Project: 201807 - Columbia Jail
385 NW Quinten St
Lake City, Florida 32055

FOOTING @ CELL & Corridor Conection

SK-RFI-CC-48

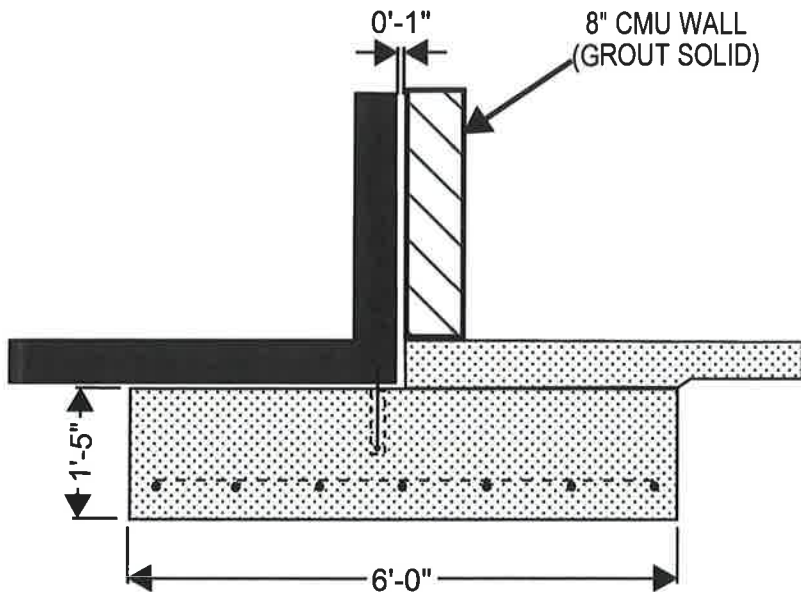
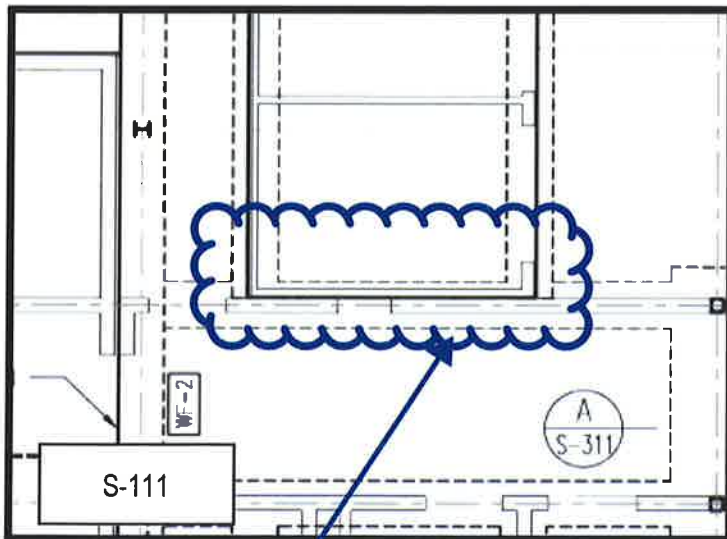
There is no detail for the footing where the pre-cast cells but up to the corridor CMU leading from the rover station. E3/A-581 shows 1" between the cell and the CMU. We propose to extend the Footing out as shown on attached sketch SK-RFI-CC-48.

Official Response: Richard Novitsky (Dewberry) responded on Monday, January 11th, 2021 at 5:50PM EST
Proposed detail is acceptable.

APPROVED
